# Manual Supplement

Manual Title: 752A  
Print Date: May 1983  
Revision/Date: 1, 4/84

Supplement Issue: 6  
Issue Date: 6/99  
Page Count: 8

Figure 1.

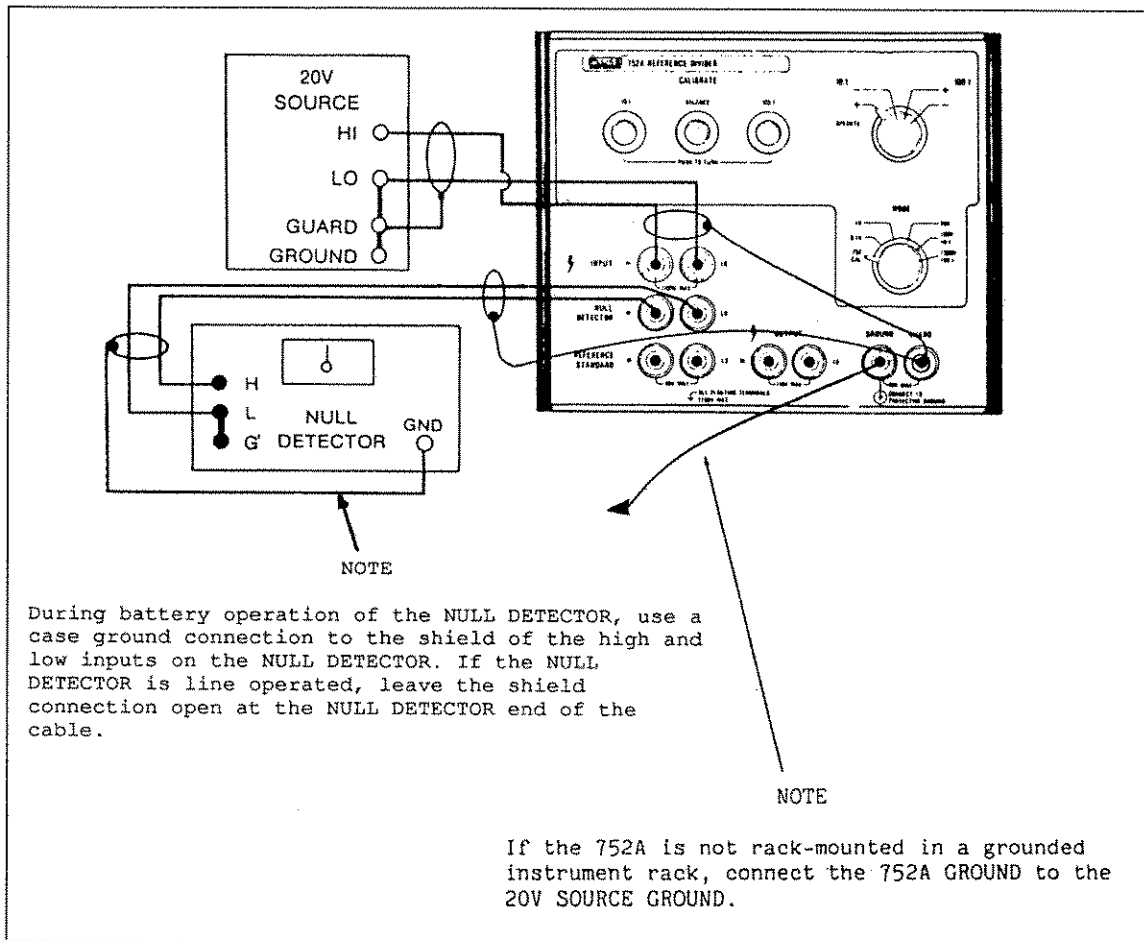
On page 2-4, replace Figure 2-2, with Figure 1.

Figure 2.

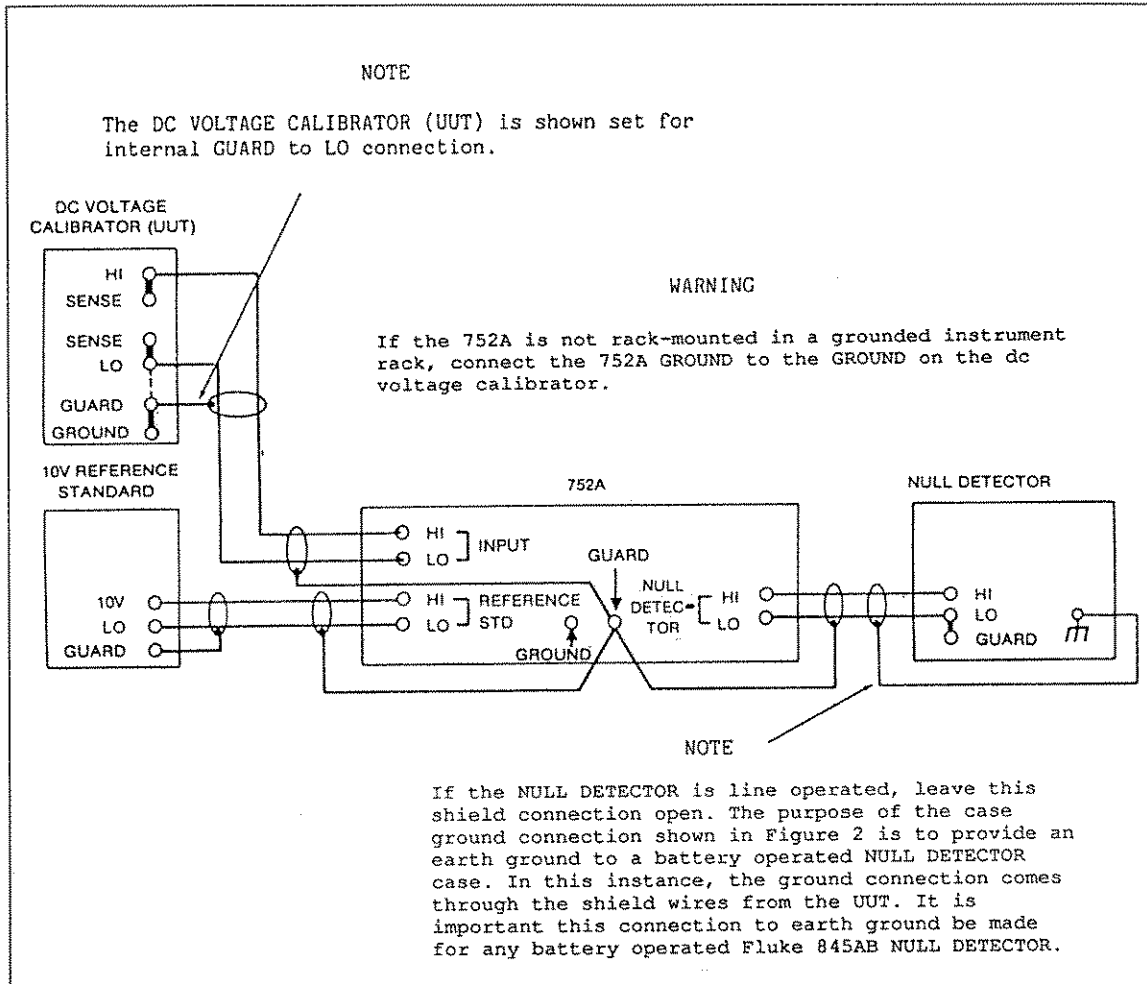
On page 2-6, replace Figures 2-4 and 2-5 with Figures 2 and 3 respectively.

*Note*

*If either the 752A or the KELVIN-VARLEY voltage dividers are not grounded through a rack-mounted case, provide an earth ground for both instruments.*

Figure 4. Equipment Connections For Leakage Resistance Test

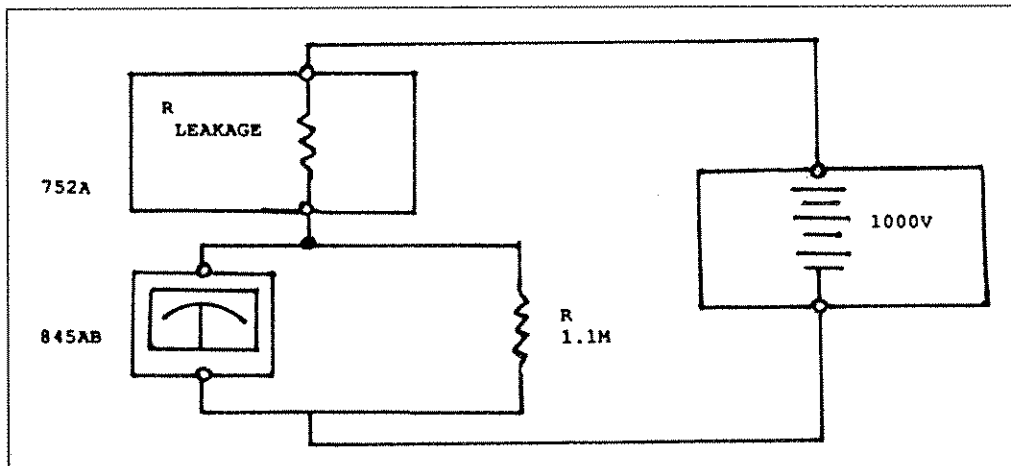
On page 4-7, after paragraph 4-31, add the following procedure:

4-31a. LEAKAGE RESISTANCE TEST PROCEDURE

4-31b. Perform the following procedure to prevent ratio errors caused by leakage. It is recommended that this procedure be done annually. Refer to Figure 4 for equipment connections.

1. Place the 752A on a sheet of dielectric. Use teflon insulated wires to connect the 1000V source to the 752A and 845AB. Connect a 1.1 megohm resistor across the 845AB input terminals to bring the input resistance to 1 megohm.
2. Connect the 1000V source to the 752A Input High binding post.
3. Connect the 845AB positive (+) input to the 752A Guard binding post.
4. Connect the 845AB negative (-) input to the 1000V source negative output binding post.
5. Set the 752A switches as follows:  
 Mode switch-----Set to "1000V (100:1)" position.  
 Operate switch-----Set to "OPERATE" position.
6. Apply 1000V from the source.
7. The 845AB reading must be 0.5 mV or less to pass.
8. Set the source to standby and change the 845AB positive input lead from the 752A Guard binding post to the 752A Ground binding post.
9. Repeat steps 6 and 7.

Figure 5.

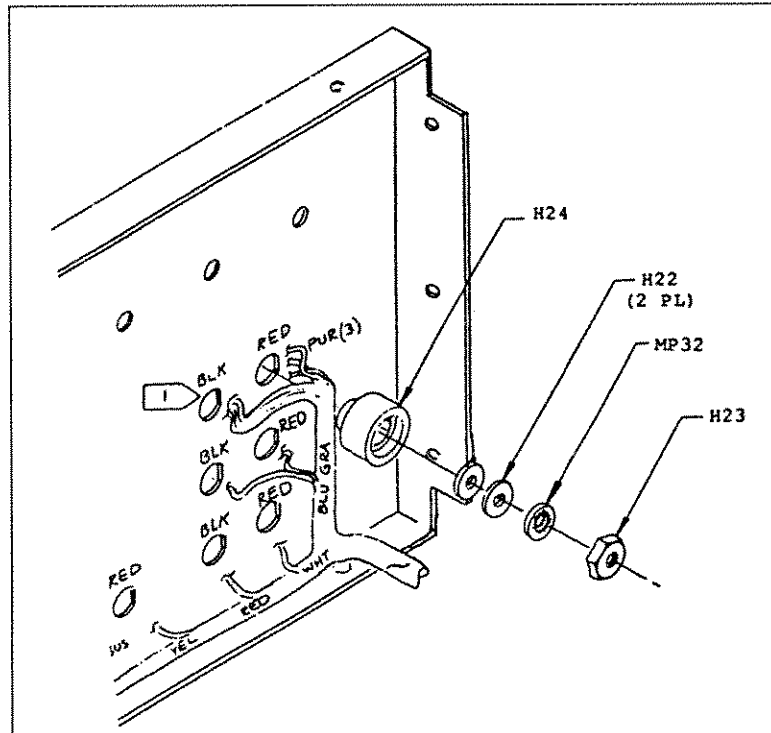
On page 5-5, Figure 5-1, add H22, H23, and H24 as shown in Figure 5.

Add: H22IWASHER,FLAT,BRASS,#8,0.32 THK I631606I86928I5714-162-32I20

H23INUT,HEX,BR,8-32 I631614I73734I631614 I10

H24IB-P-WASHER I606293I89536I606293 I10

Figure 6.

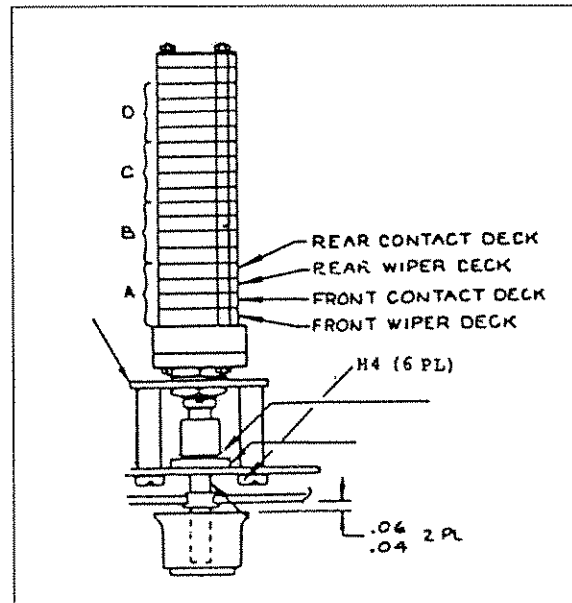
On page 5-5, Figure 5-1, change the view of H4 as shown in Figure 6.

Figure 7.

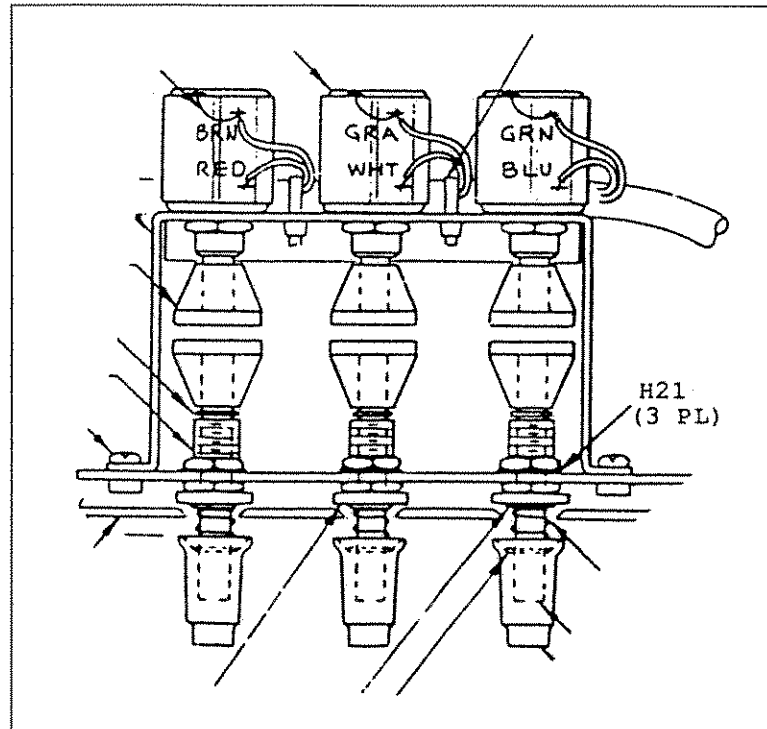
On page 5-5, Figure 5-1, add H21 as shown in Figure 7.

Add: H21|WASHER,LOCK,INTERNAL|129957|78189|1220-05|1
